AMENDMENTS TO THE DRAWINGS

The attached sheet of drawings includes changes to Figure 7.

FIG. 7

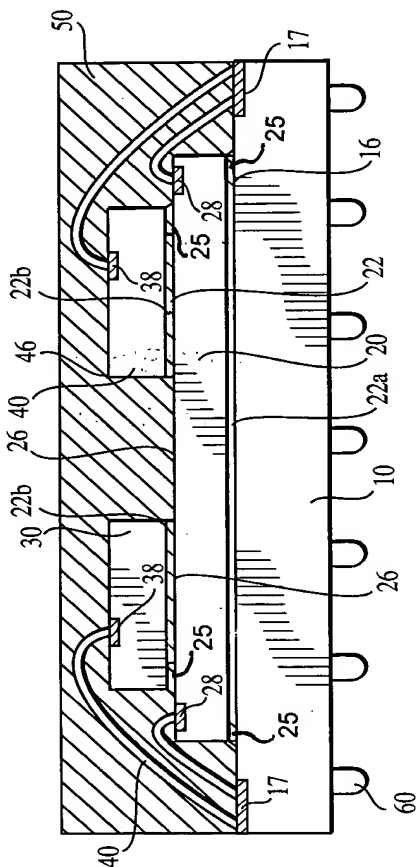
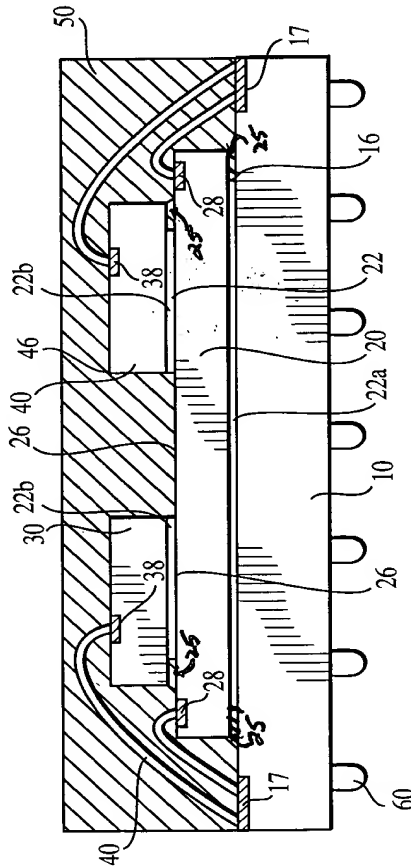
Figure 7 has been amended to include cavity 25 between the first semiconductor die 20 and the supporting structure 10.
